PRAIRIE ISLAND NUCLEAR GENERATING PLANT  
Docket Nos. 50-282 License Nos. DPR-42  
50-306 DPR-60

Type C Testing of the Containment Spray System,  
Supplemental Information in Response to  
Inspection Reports No. 50-282/88016(DRS) and 50-306/88016(DRS)

Prairie Island Unit 1 Containment Spray System

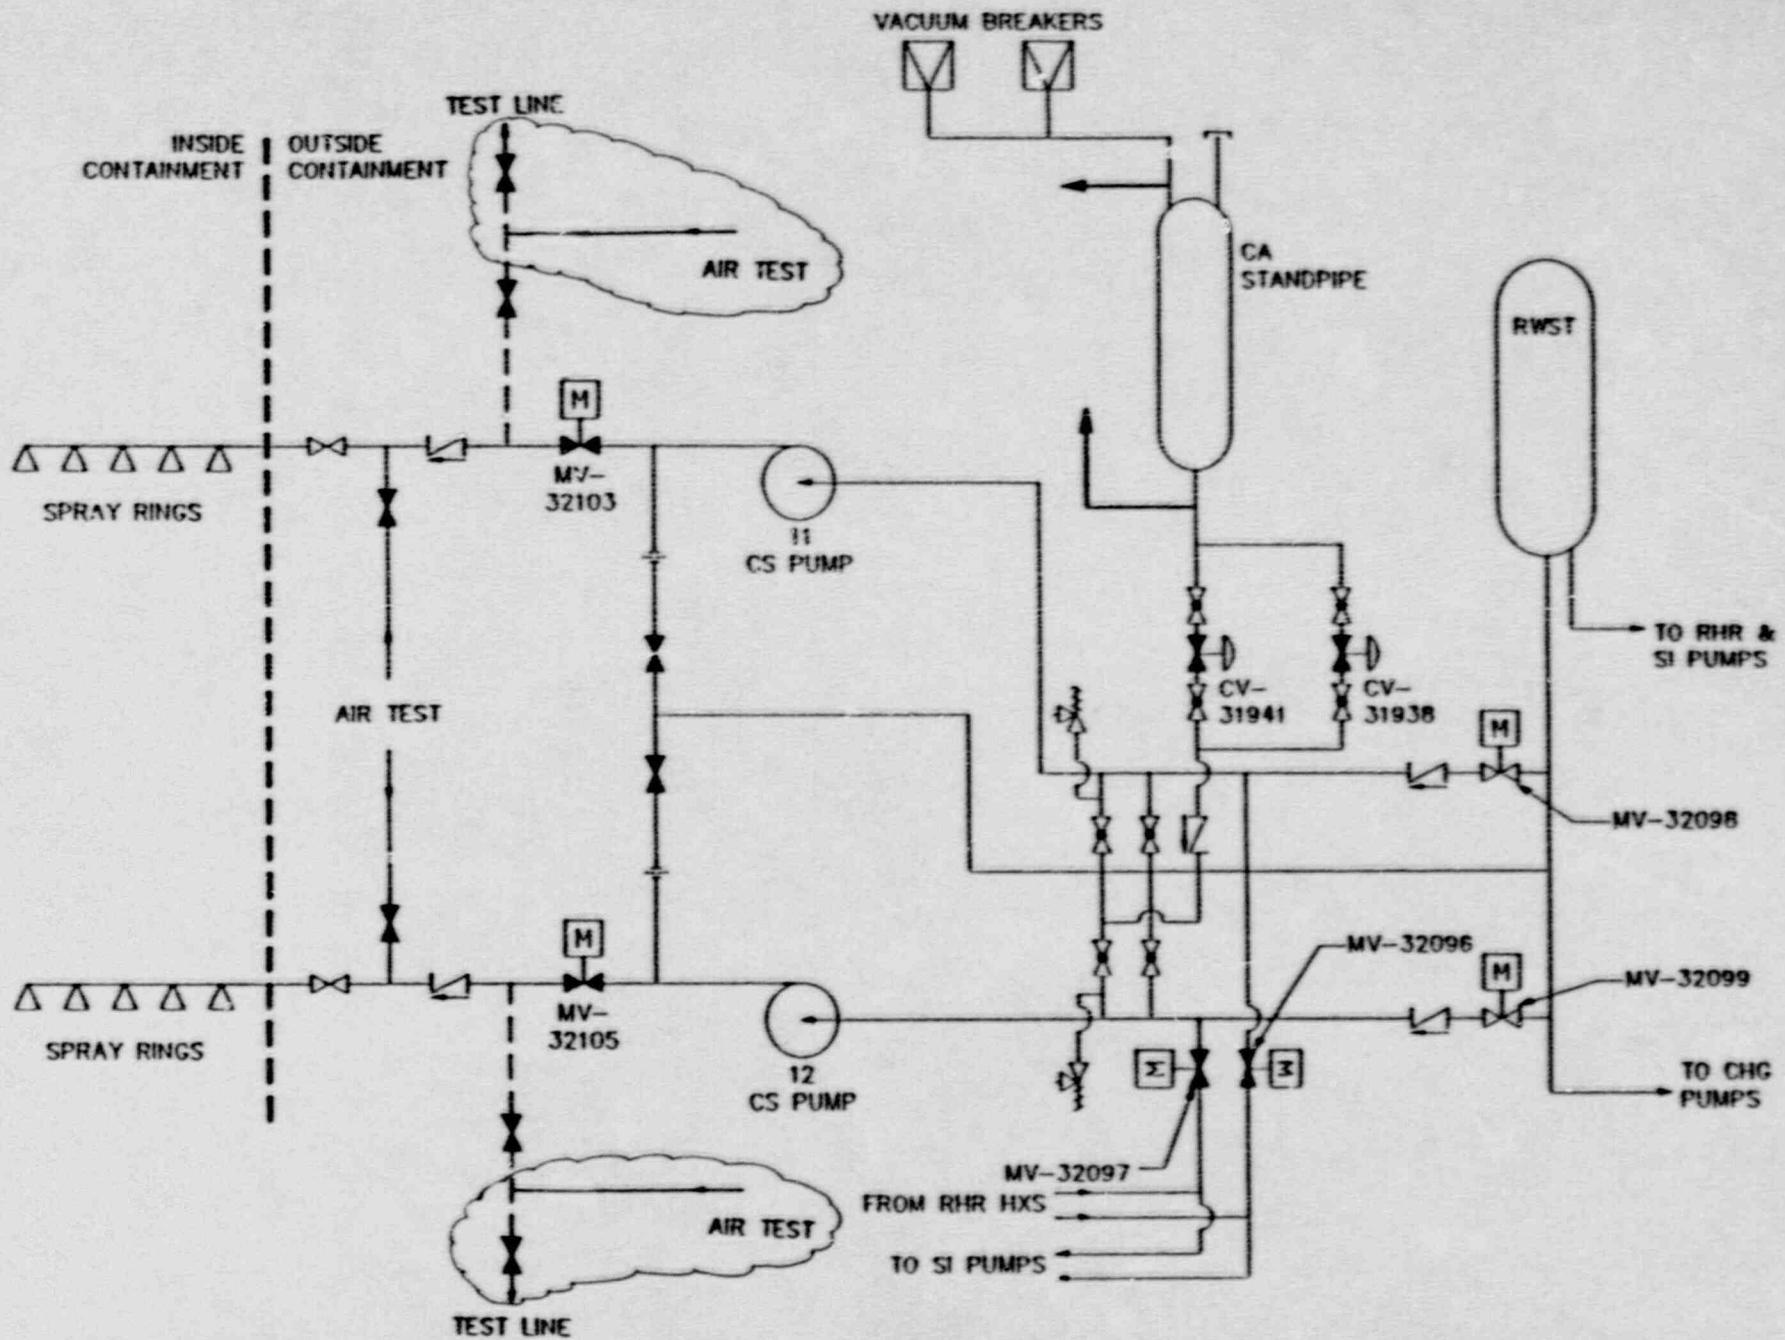
Air test connections will be added to allow pressurization of the containment spray piping between motor valves MV-32103 and MV-32105 and the down stream manual isolation valves (See attached figure). This modification will be made to the corresponding Unit 2 valves. These modifications will be completed during the next refueling outages, now scheduled for January 1990 for Unit 1 and September 1990 for Unit 2. Following completion of the modifications, motor valves MV-32103 and MV-32105 (and the corresponding Unit 2 valves) will be Type C tested in accordance with Appendix J.
